Hydrological expert evidence statement

Review of stormwater management and flooding for the proposed development

**1 Buckland Street, 20 Montis Lane, 18-46 Saade Street,
adjoining reserves and road reserves, Epsom**

**Greater Bendigo Planning Scheme Amendment C248gben
Planning Permit Application No. DS/207/2019**

Figure 7: Local stormwater inundation from 1% AEP rain events under existing conditions

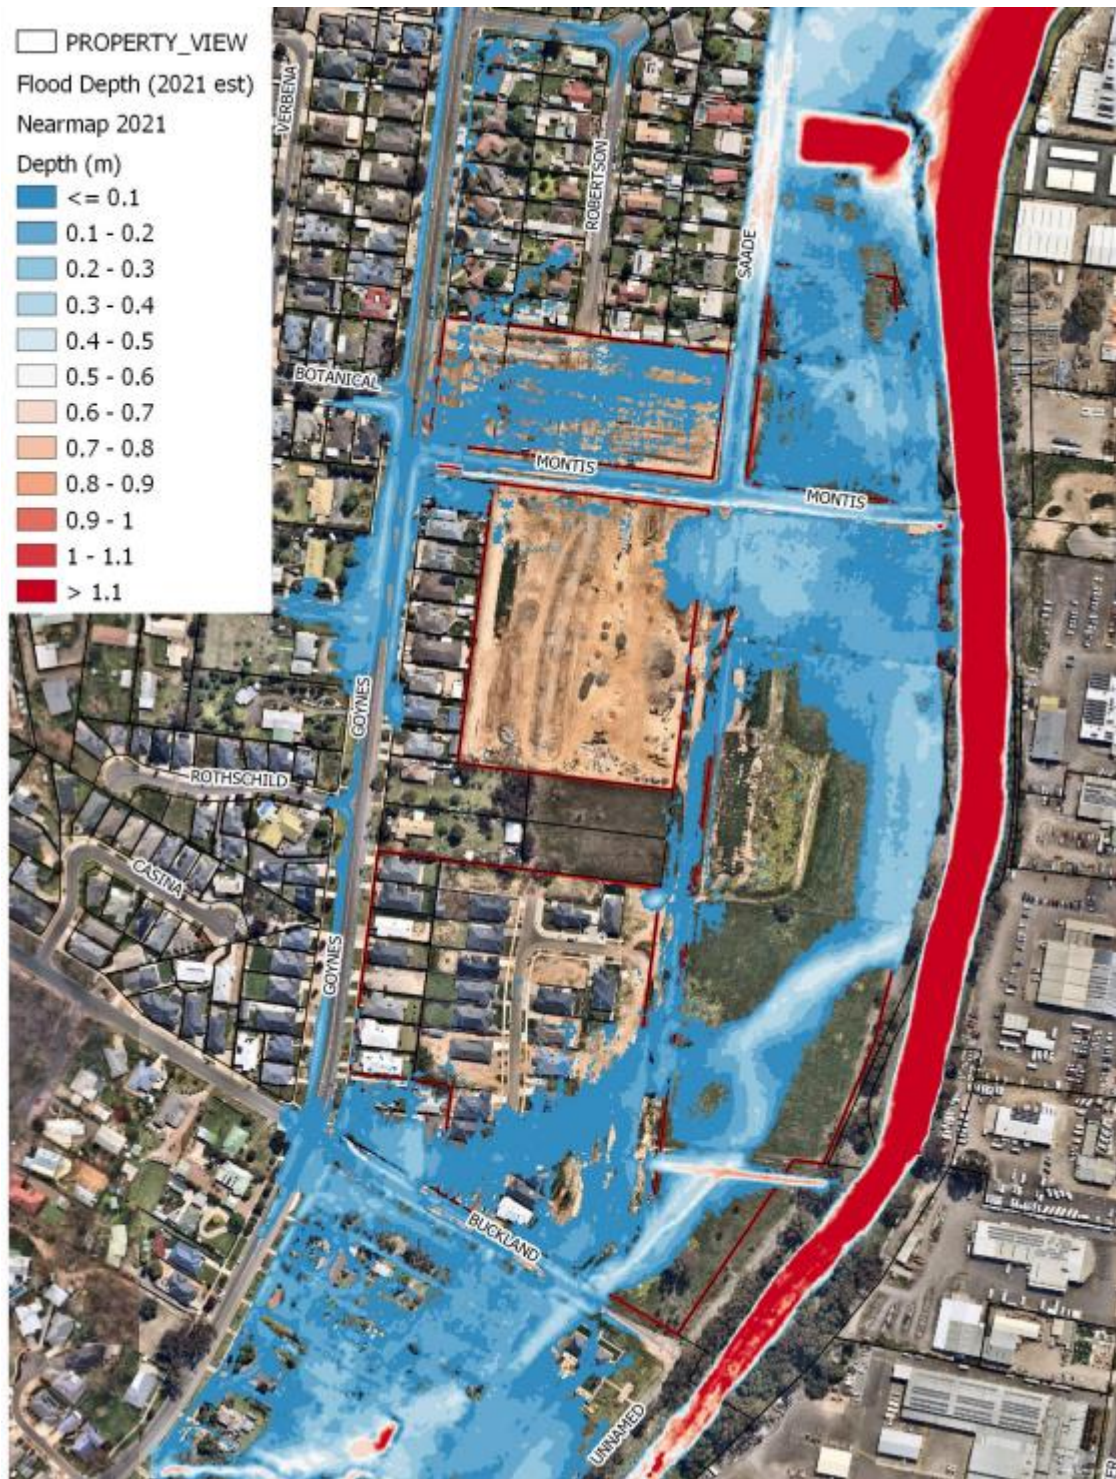
Figure 7 demonstrates that the hydraulic modelling produced similar flood shapes and depths to the flood maps provided by North Central Catchment Management Authority NCCMA (see Figure 4). The differences in the flood shapes around Buckland Street indicate that the hydraulic model includes more stormwater than the Bendigo Urban Flood Study in 2013. The flood shapes are also influenced by changes in the land surfaces and infrastructure within the external catchments. The flood shapes and depths of developed conditions are presented in Figure 8.

Figure 8: Local stormwater inundation from 1% AEP rain events under developed conditions

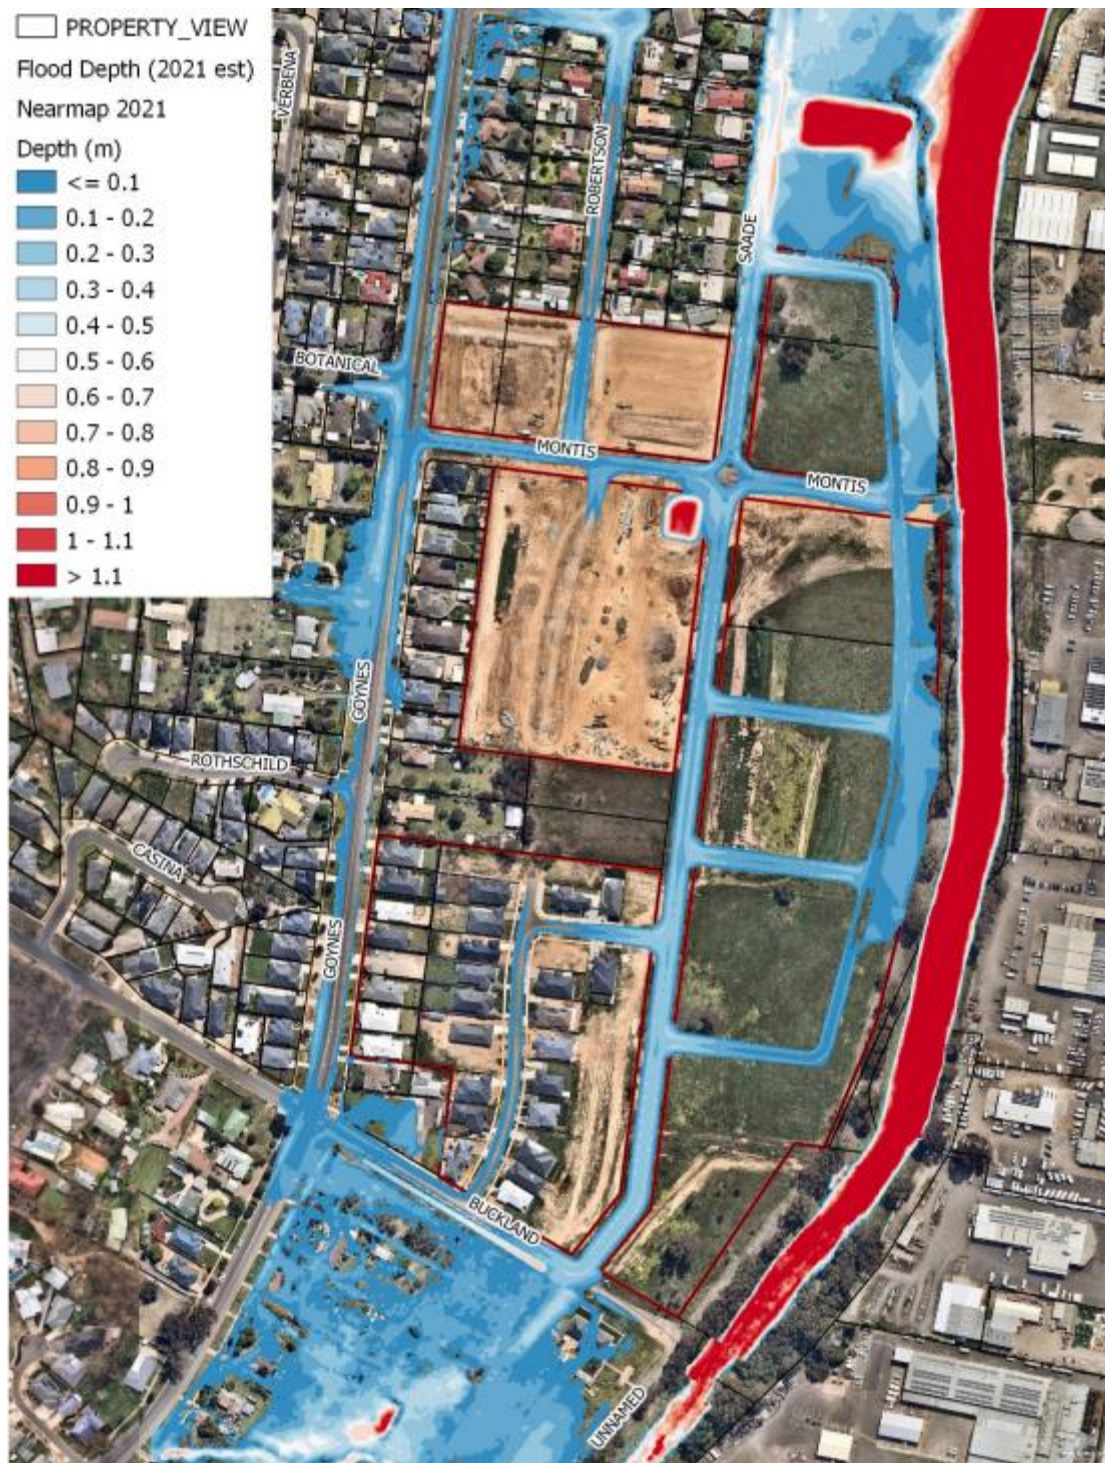
Figure 8 demonstrates that stormwater inundation from 1% AEP rain events is retained within the road profiles and in the reserve adjoining Bendigo Creek. Most of the depths of stormwater inundation are less than 0.3 m.

Figure B1: Extract from the Terraco feature survey showing the contours of ground levels and the raised bicycle path near Buckland Street and Bendigo Creek

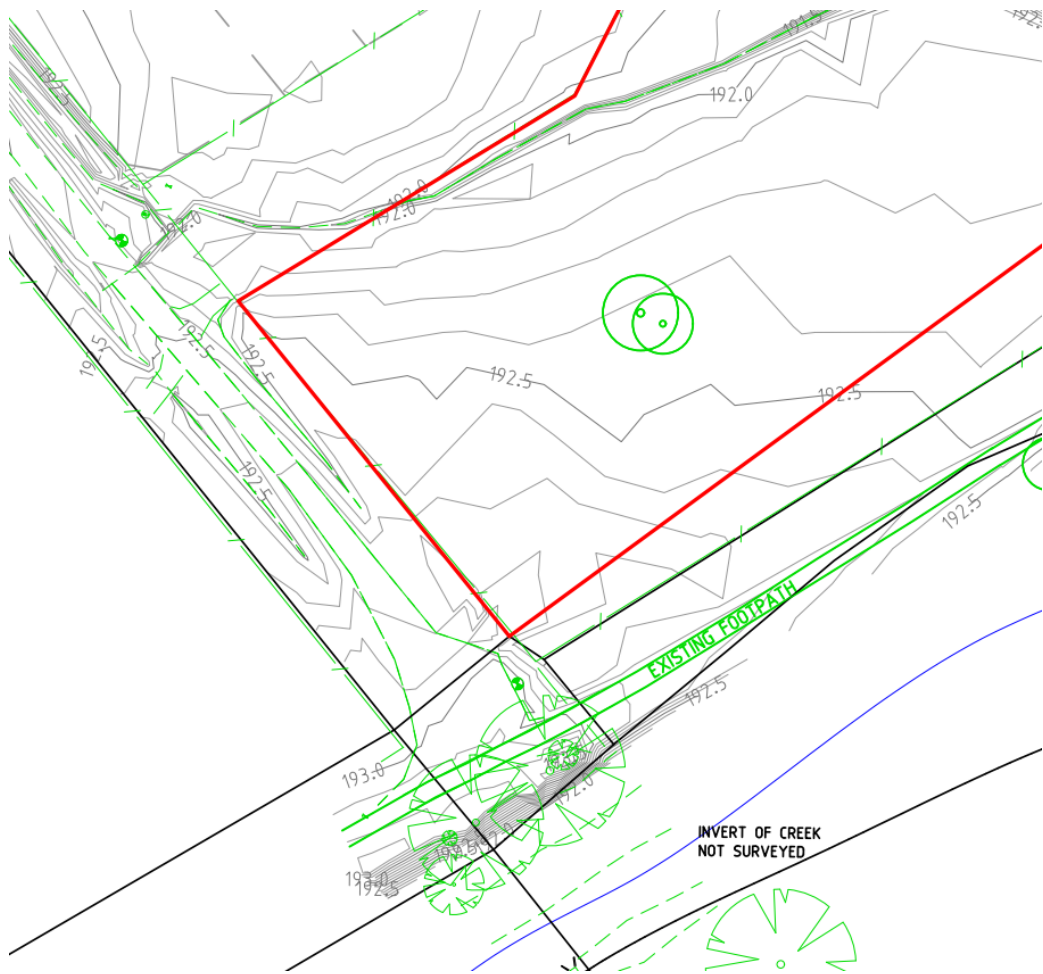
There is approximately 0.5 m freeboard to the 2100 flood level at this location. The derivation of the 2030 and 2100 peak flows using the climate change ratios derived in this report at Table 6 indicates that greater freeboard may be available in 2100.
